Determination Report

DETERMINATION OF THE JI TRACK-1 PROJECT:

“Energy efficiency investment program at
OJSC ArcelorMittal Steel Kryviy Rih”,
Ukraine

REPORT No. 1155637

Figure 1. IRR of each sub-project with and without ERU revenues (gained through JI activity) comparing with corporate WACC

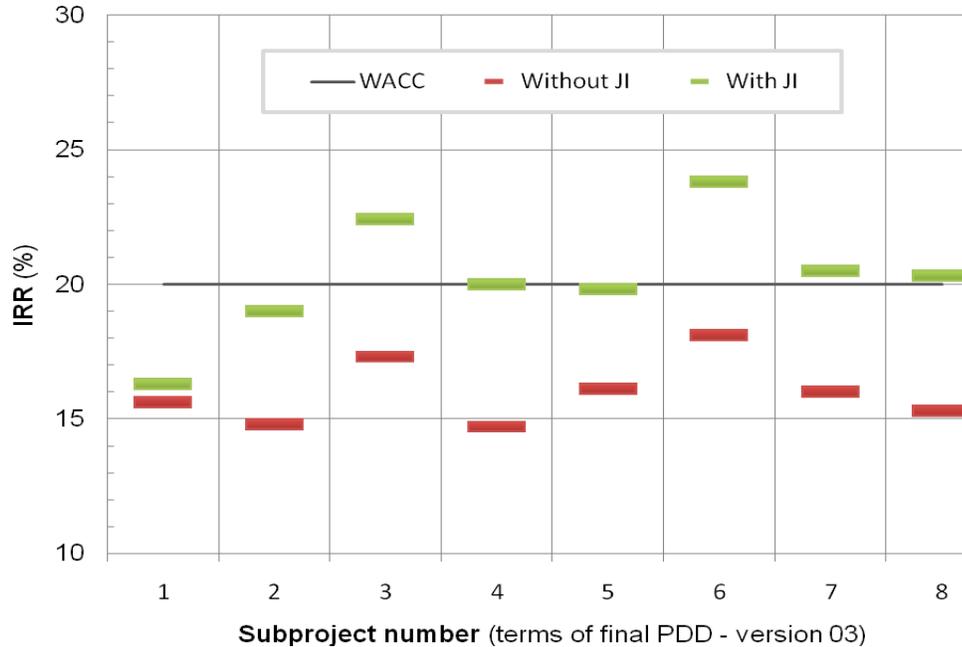
Only in case of SP No. 6 (in terms of PDD version 02) IRR significantly larger than WACC and could be consider as “profitable” even without additional revenues from the selling of carbon credits. Therefore, project proponent was requested to specify additional hard proves why this project is in spite of its financial attractiveness is not business as usual or to exclude this SP from whole project (CR4). As a resolution of this clarification request PP decided to exclude SP No 6 (in terms of PDD version 02) from the updated PDD (version 03). Final figure of IRR for each SP represented via figure 1.

Figure 1 clearly shows that IRR of each SP without consideration of ERU revenues lies beyond the WACC and will not be implemented without JI mechanism. On the average the IRR of each SP lays approximately 4% under the assessed WACC benchmark.
